SPECIAL USE APPLICATION FOR APPEAL

NUMBER OF DOCKET APPEALED: SU-11 -13

We appeal the decision approving a special use permit for Rainbow Solar Farm

Comments on Site Plan for "Rainbows Solar Energy"

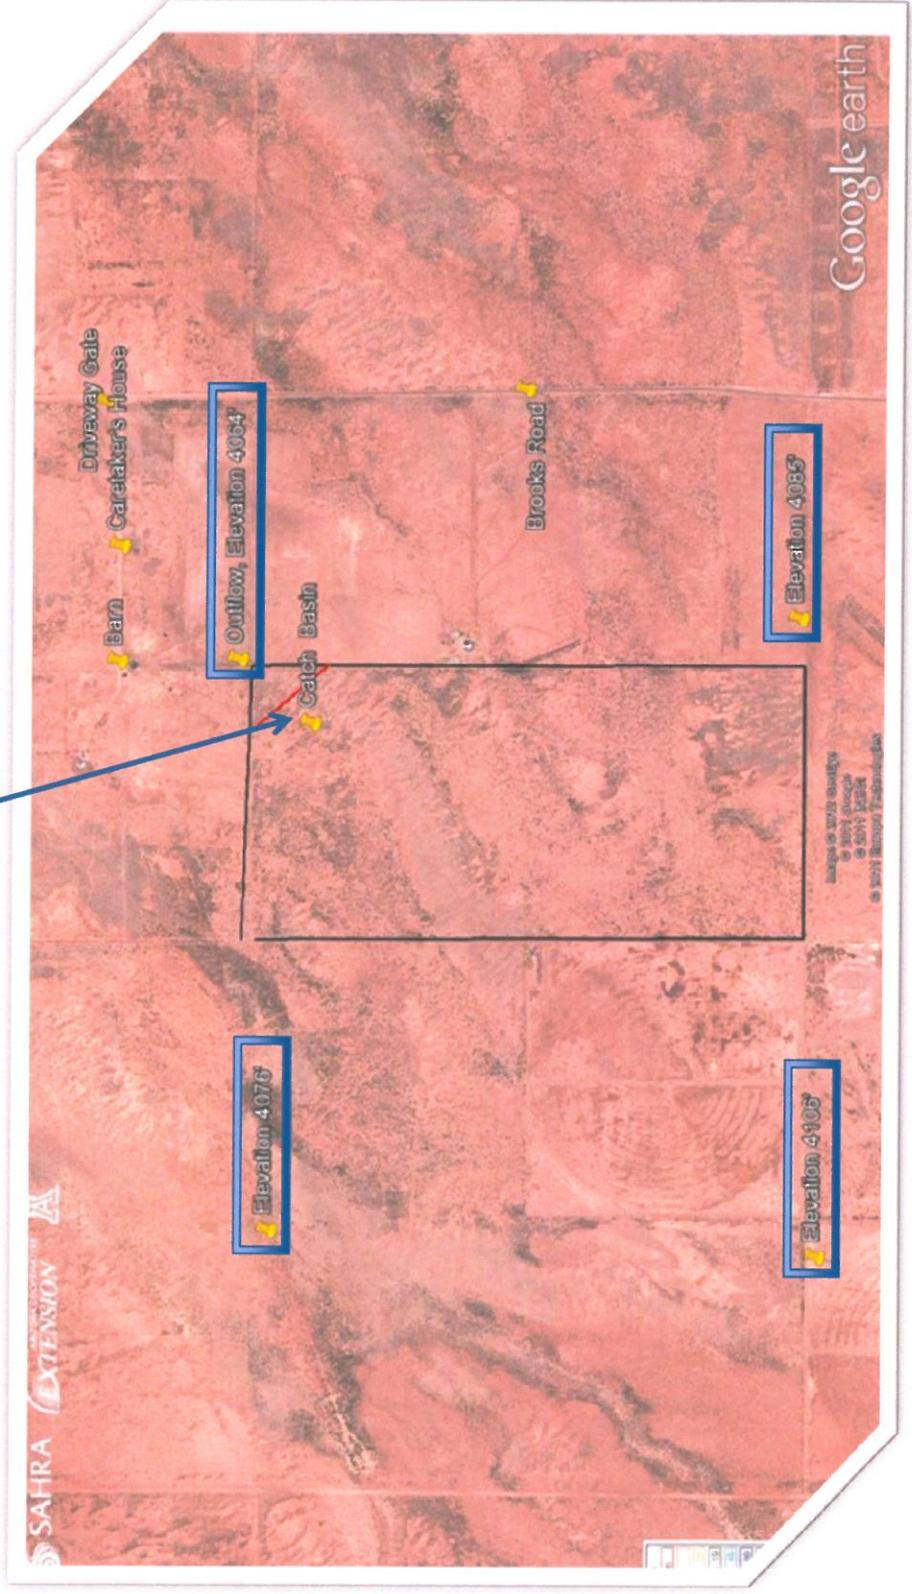
The arrows designate the flow of water directing it into a retention pond at the extreme northeast corner. The retention pond capacity is 19.16 acre feet. Two inches of rain covering 320 acres produces 54 acre feet of water, nearly three times the capacity of the pond. Overflow from the pond passes through a spillway in the northeast corner of the pond and into animal pens on my farm.

I have included the surface elevations at the four corners of the project. The natural flow is from the southwest to the northeast and corresponds with the pattern of vegetation markings running diagonally across the property. The proposed retention pond is marked in the northeast corner.

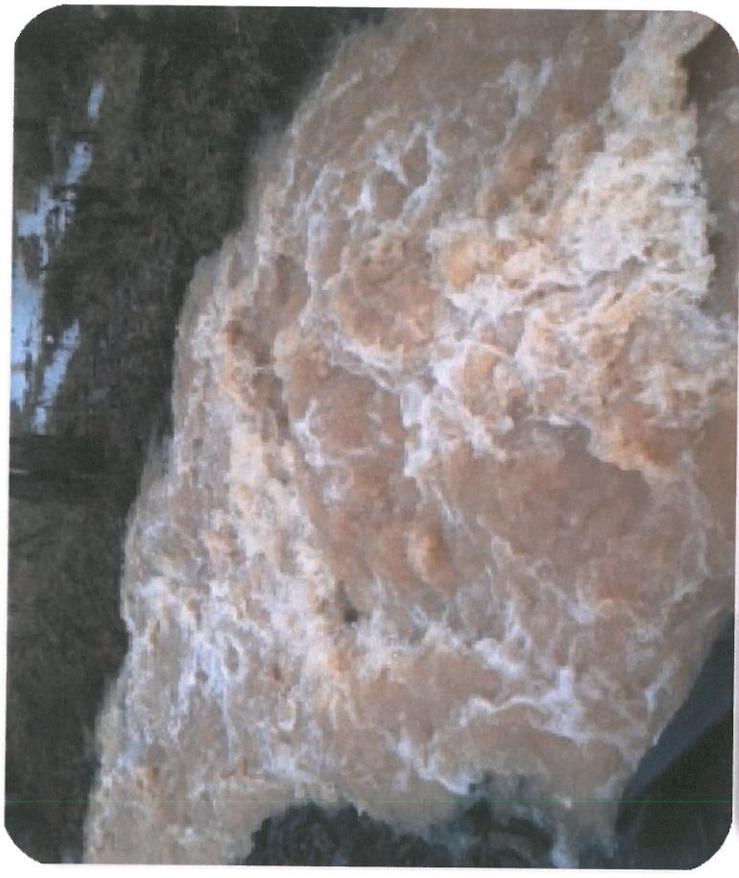
These are photos of a pond and spillway on my farm in Oregon. The pond catches the run off from approximately 100 acres. It was raining hard on the day of the photo creating a torrent of water passing through the spillway. The retention pond on the solar facility will capture the run off from 320 acres passing it through a spillway such as this and onto my farm.

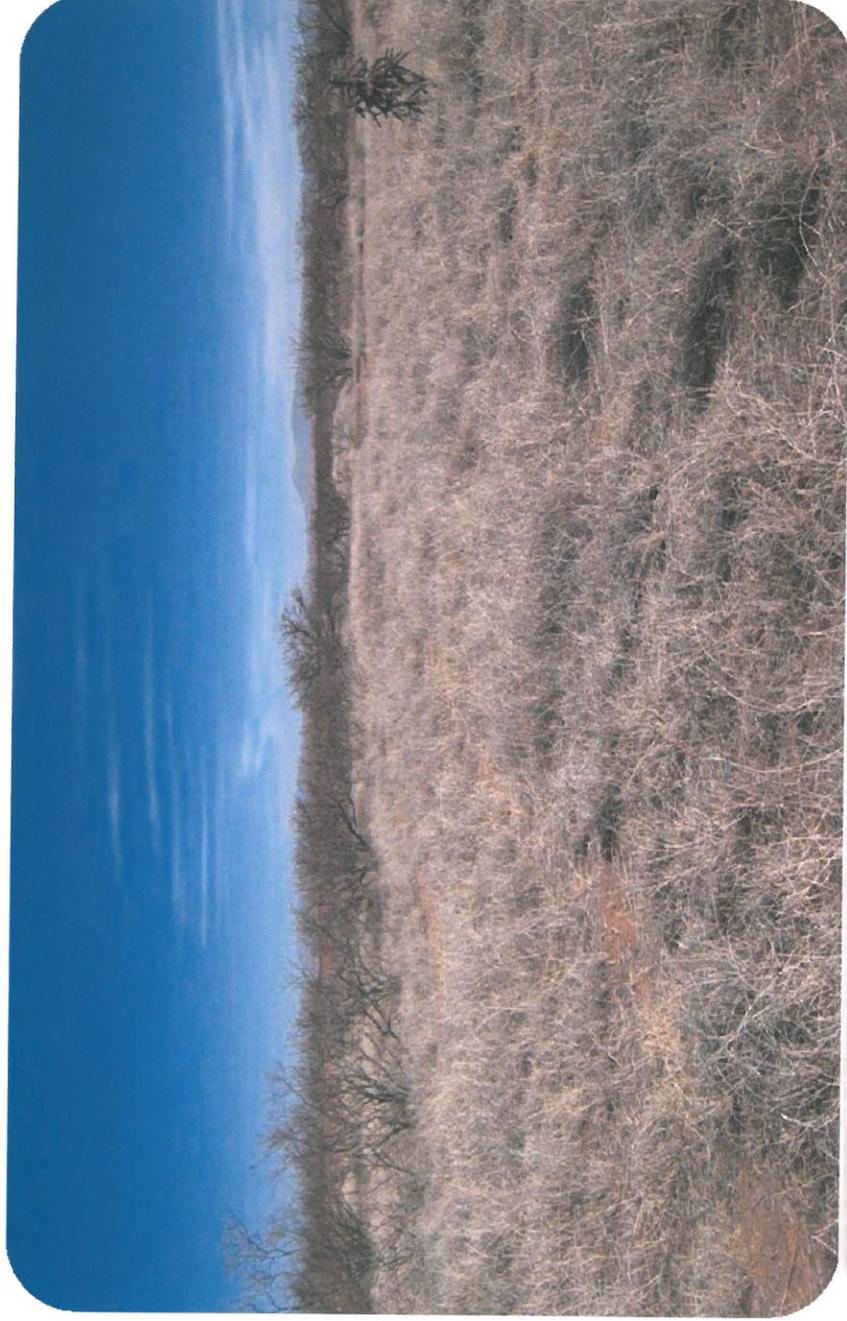
This is a recent photograph taken at the site of the proposed solar farm. The vegetation is typical of the entire 320 acre site. It is easy to understand how the vegetation naturally restricts the flow of surface water and why its removal will result in an increased volume of flow of storm water

SITE PLAN FOR "RAINBOWS SOLAR ENERGY"

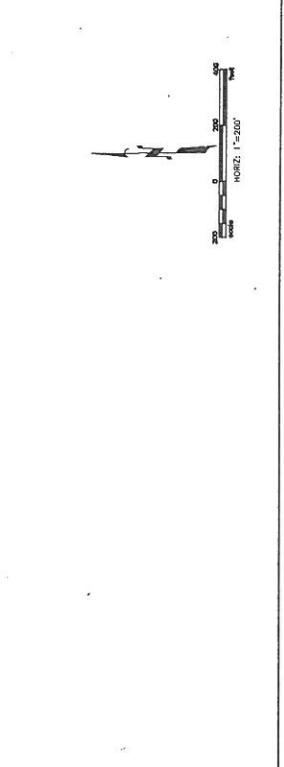
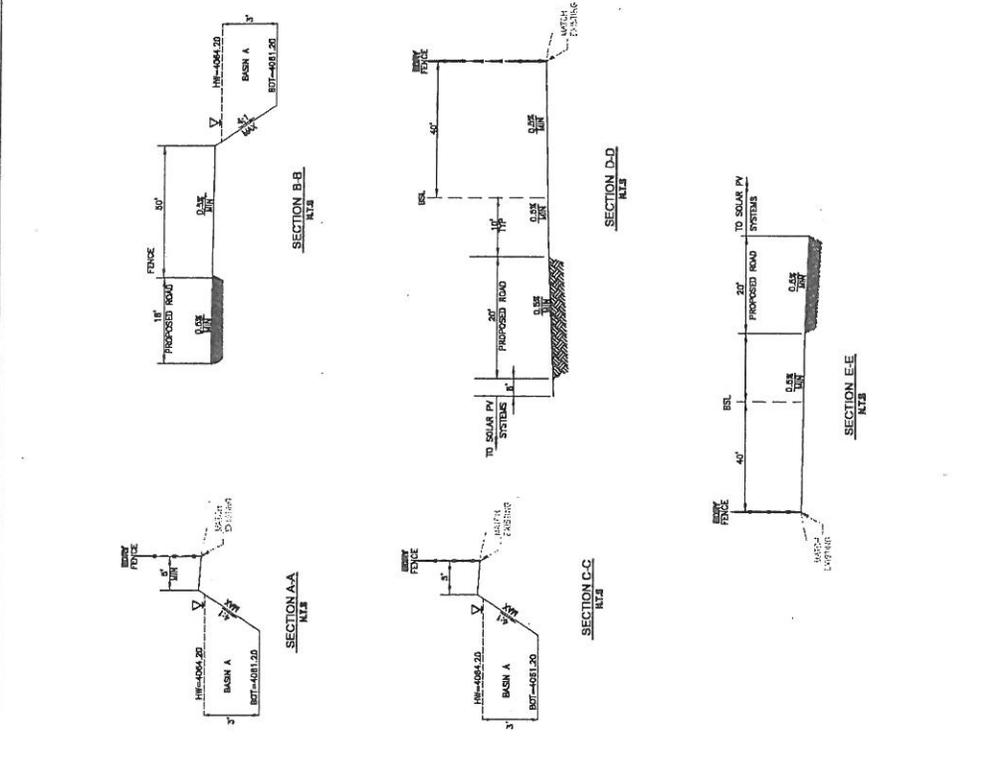
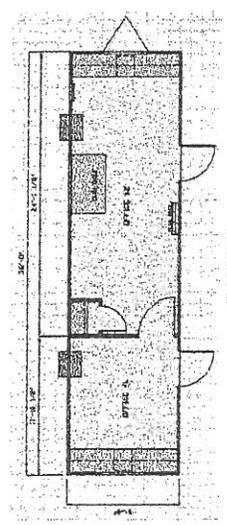
1. The existing topographic contours, as shown on Sheets 2 & 3 of the plan, indicate that runoff during storm events will be toward the east in the southern half of the property to be developed (Sheet 3), and toward the northeast in the northern half of the property (Sheet 2). Thus runoff leaving the property, under current conditions, can flow both across the eastern boundary and across the northern boundary.

2. According to the drainage plan (Sheets 2 & 3), runoff in the southern half of the property will be directed due north, and runoff in the northern half will be directed either north or northeast toward a retention basin in the northeast corner, from whence the outflow is indicated to be across the northern boundary.

an increase in runoff per unit area of the site (due to factors such as removal of vegetation, installation of solar panels, and compaction of soils during construction and operation). This increase in runoff per unit area is acknowledged in the plans, in terms of an increased runoff coefficient (C value) in the "Retention Required Equation" (Sheet 2, lower left-hand corner). The runoff coefficient is estimated by the developer to increase from 0.41 pre-development, to 0.66 post-development.

10. These calculations consider only the effects of a single, 100-year recurrence, 1-hour precipitation event. The pond has not been designed to hold excess runoff from multiple storm events that occur within a few days (such as occurred in late July, 2006), or storm events that last more than one hour on a single day. Weather data for the area show that single-day precipitation events of two inches or more are on record for most summer dates.

11. The capacity of the retention basin to prevent flooding on adjacent properties during a sequence of storm events will depend on the permeability of the underlying soil or sediments. Soil hydrologic properties have not been described or evaluated in the plans as presented.

The proposed solar farm improvements will cover approximately 51% of the site with panels, thus changing the runoff characteristics of the significantly. The Grading and Drainage Plans, sheets 2 and 3, show the construction of a perimeter access roadway along the east, west, and north boundaries of the site. The detailed sections, B-B, D-D, and E-E show that the site will be graded toward the

The proposed "Basin A" has been sized to hold the increased runoff from the site resulting from the additional impervious area during a 100 year storm event. The analysis in the lower left hand corner of Sheet 2 shows that the increased runoff is 17.38 acre feet in volume. Our analysis of the project area would support the reported increase in runoff volume due to the proposed improvements during such an event. However, the proposal to re-grade the perimeter of the site to direct all of the surface runoff to the pond is a very significant change to the present drainage pattern for the site.

These assessments will, in all probability, indicate that the development, as planned, has a foreseeable likelihood of causing increased flooding on adjoining property. Possible methods for mitigation include (1) redesign of the drainage pattern and eastern boundary road to maintain the existing pattern of distributed runoff, (2) enlargement of the proposed retention basin to give sufficient capacity, or (3) a combination of these measures.

- (1) The grading and drainage plans for the site be redesigned to more closely mimic the existing drainage pattern as runoff exists the site.***
- (2) Mr. Noble be afforded an opportunity to review and comment on any future grading and drainage plans prior to permits being issued for the project.***
